## SIGN REVIEW BOARD MEMORANDUM

**FROM:** The Office of the City Manager   **DATE:** March 9, 2026  
**SUBJECT:** SRB26-0021 Public hearing and consideration of a request from Elements of Architecture Inc. for a variance to Chapter 106 (Signs) of the North Richland Hills Code of Ordinances regarding monument signs at 828 Harwood Road, being 80.97 acres described as Tract A1A1, Northeast Campus Addition.

**NORTH ENTRANCE**

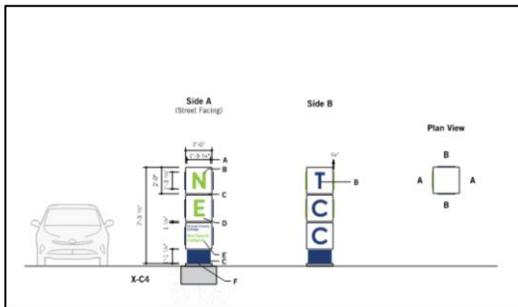
Height

- Required: Seven (7.0) feet height (maximum)
- Proposed: 17.23 feet (10.23 feet taller)

Masonry

- Required: Surrounded by at least eight inches of masonry on all sides.
- Proposed: No masonry
